File #: LN-525

DEVELOPMENT REVIEW COMMITTEE

NEW TURN LANE & ENTRY

Request: Minor Site Plan
P&Z# 23-12000032
Owner: Oldcastle APG South Inc
Project Location: 1200 NW 18th Street
Folio Number: 484227480010
Land Use Designation: I (Industrial)
Zoning District: I-1 (General Industrial)
Commission District: 4 (Beverly Perkins)
Agent: John Tice (jtice@galloherbert.com)
Project Planner: Diego Guevara (954-786-4310 / diego.guevara@copbfl.com)

AS-1.1

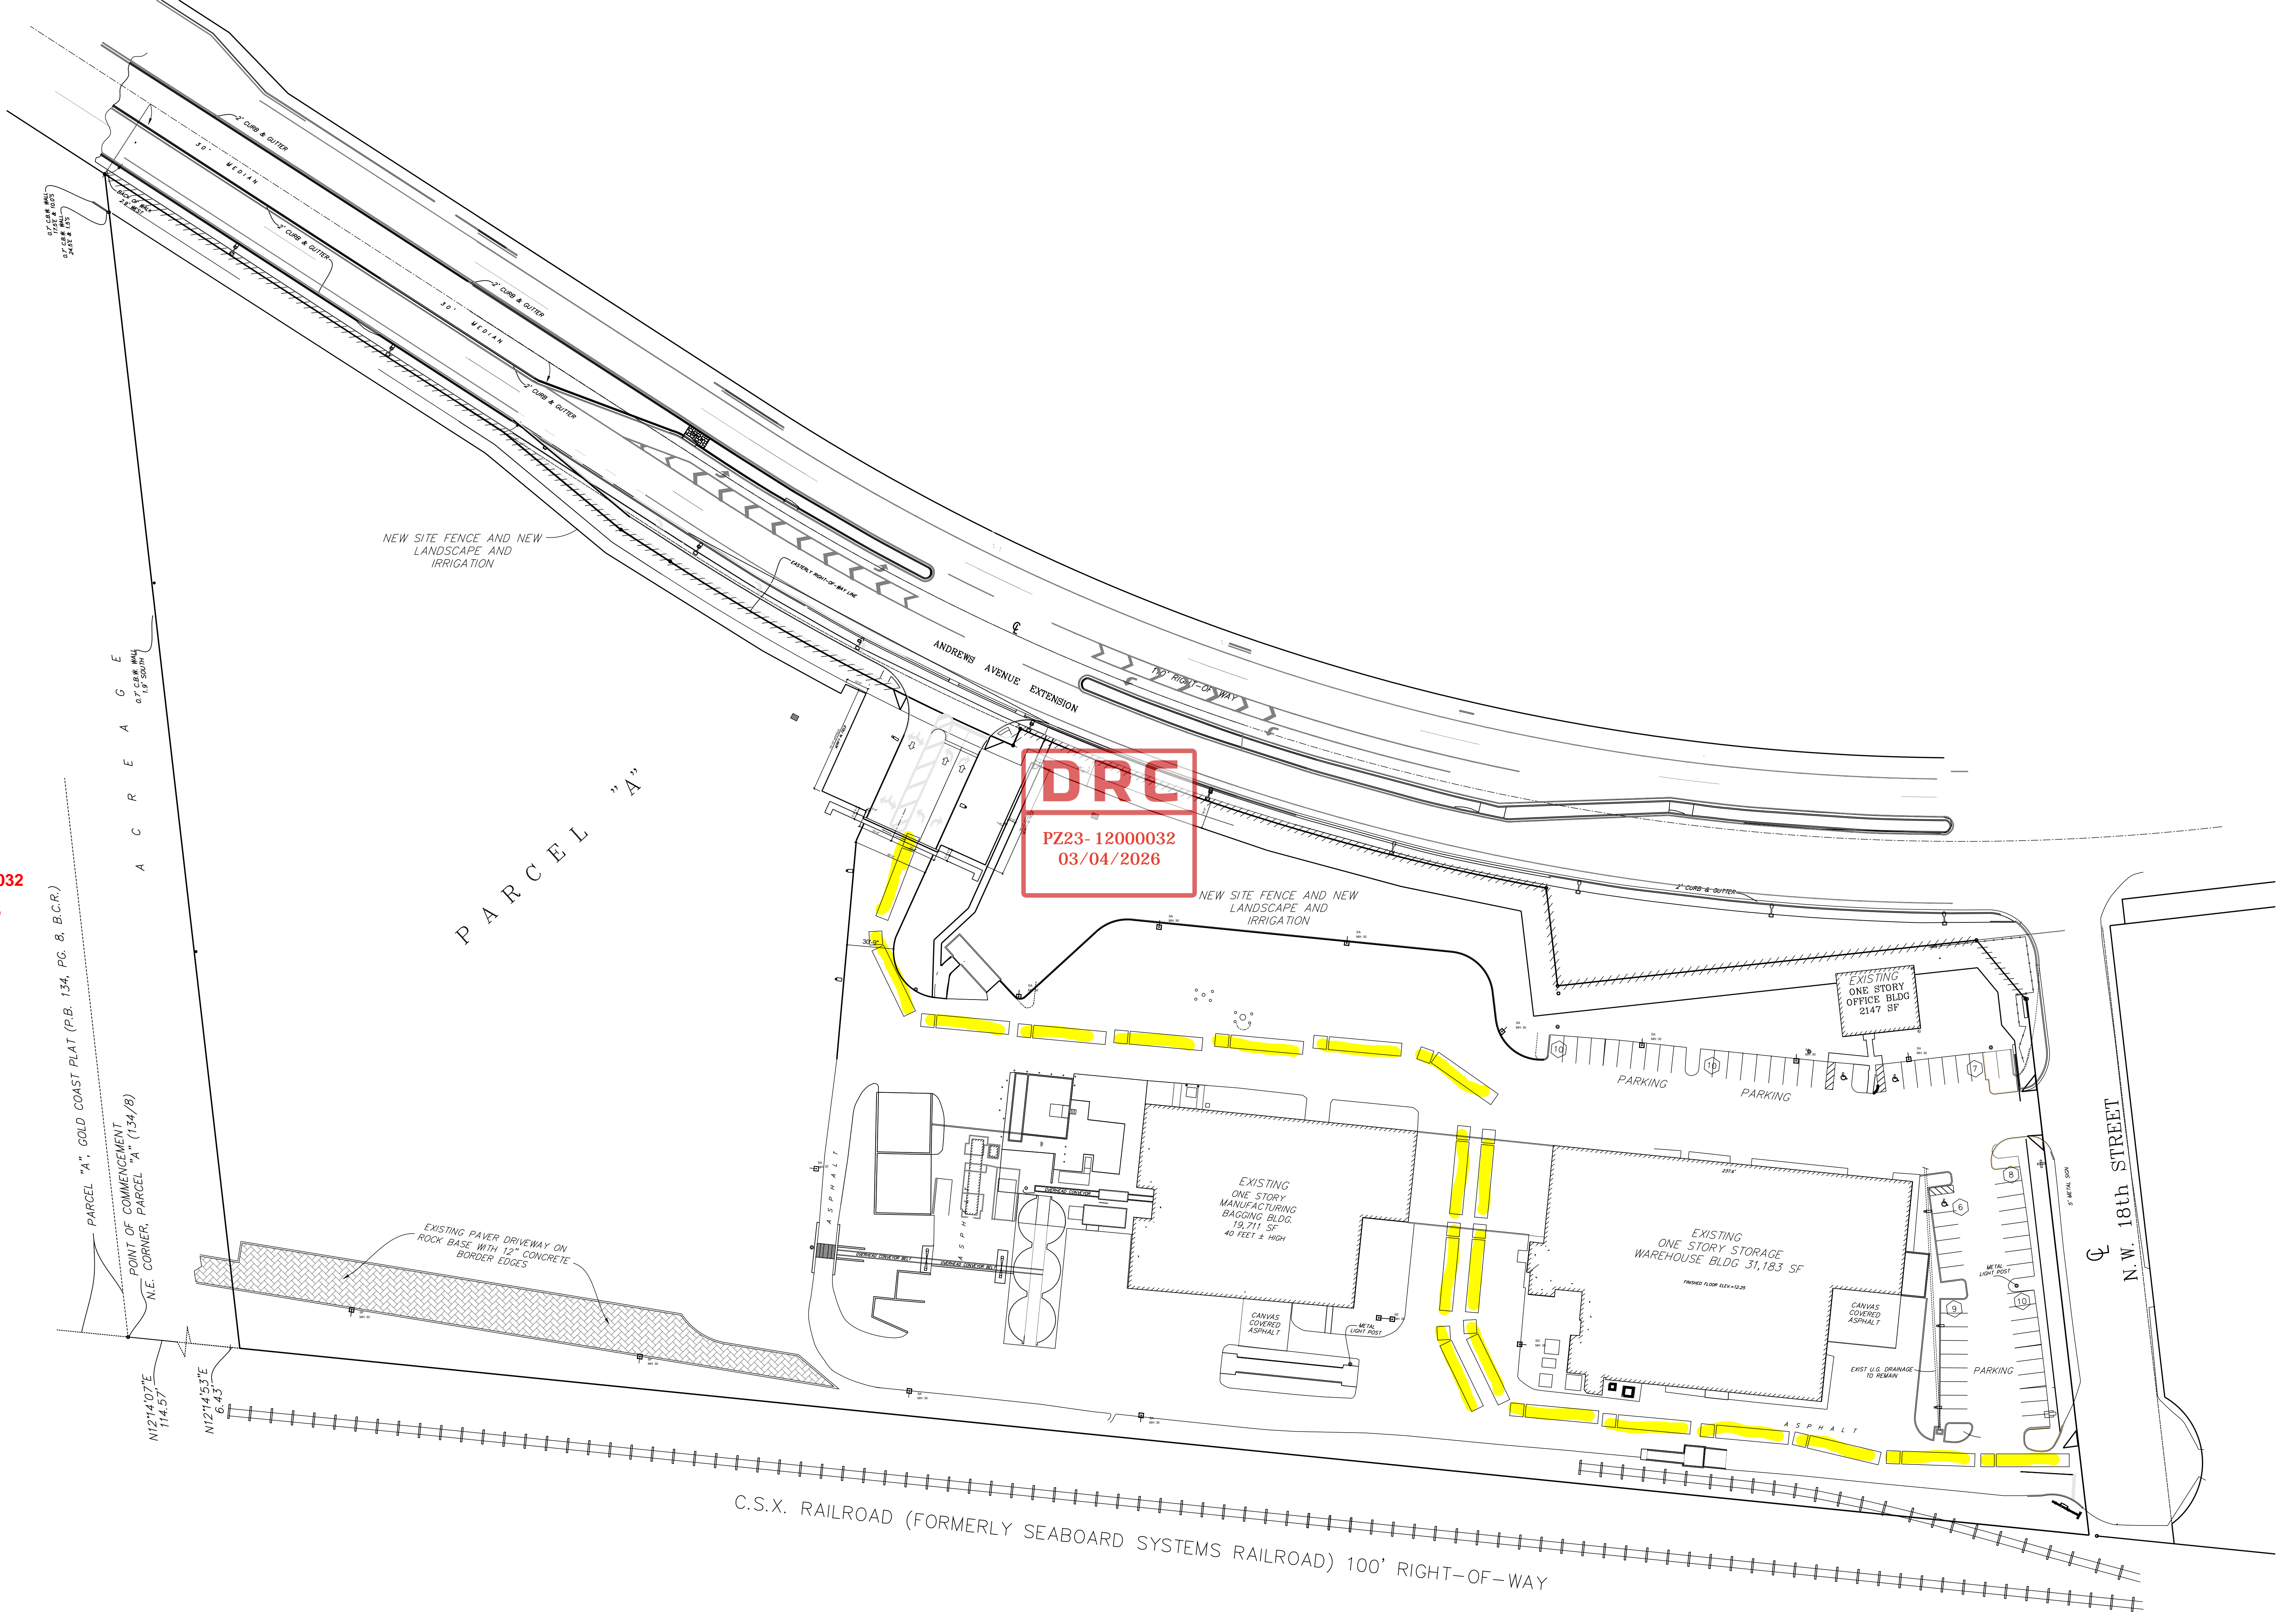
4. Add dimension showing the width at the narrowest point at the proposed entry. During the previous DRC meetings, the applicant aggrieved to add the note, however it has not been added to the plans.

5. Add dimension line showing the width at the narrowest point (goose neck) at the proposed entry.

RESPONSE: A dimension was added at the narrow point of the new entry driveway. It is 30 feet 9 inches at this point.

RESPONSE: The dimension has been added to sheet AS 1.1. Site Plan.

Landscape & Irrigation Plans For:

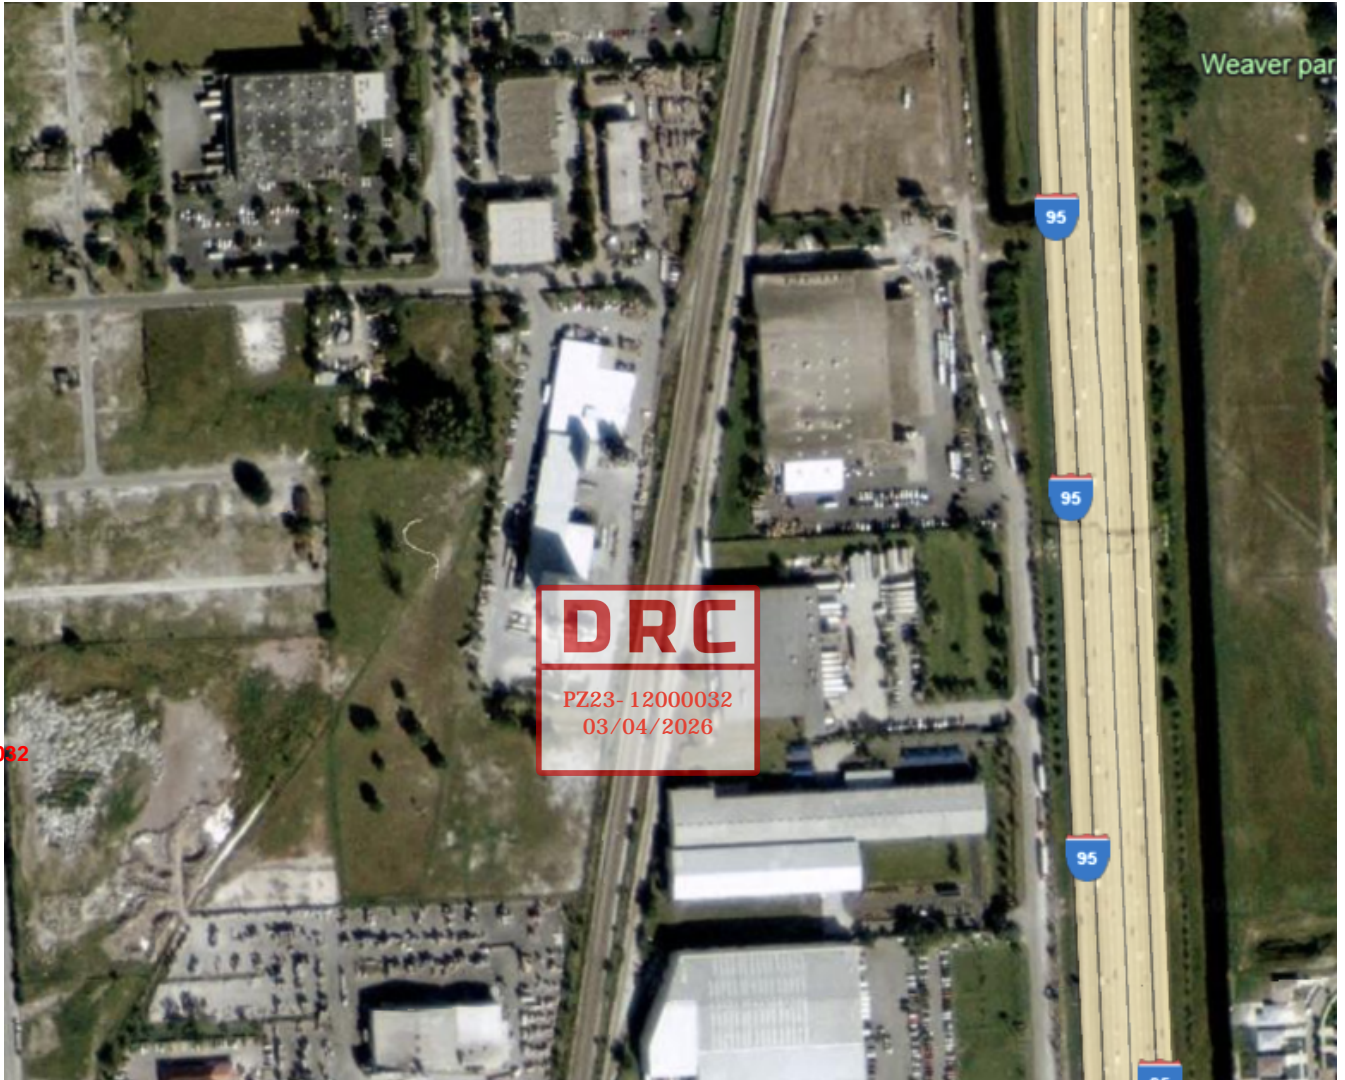
1. Include originally approved plan showing the foundation planting at time of permit submittal and note as such on the Landscape Plan(s). New plan shall include the foundation plantings along the building on both sides as per the original approved plan of record.
2. Note on landscape plans and irrigation plans. As per 155.5203.B.5.a thru e: Provide a NOTE; a rust free, automatic underground irrigation system installed in accordance with requirements of the Building Code, include a rain-sensing cutoff device, providing 100% coverage with 50% overlap.
3. Note on landscape plans and irrigation plans. Provide bubblers for all new trees and palms, staff could not locate bubbler callouts, please just provide a note on each individual sheet so as to not muddy the plan.

PLEASE SHOW ON THIS PREVIOUS
APPROVED LANDSCAPE PLAN WHICH
BUILDING BASE PLANTINGS ARE
REFERRED TO.

RESPONSE: Urban Forester note 1 states to show foundation planting at time of permit submittal and note on Landscape Plan and shall include the foundation plantings along the building on both sides as per the original approved plan of record.
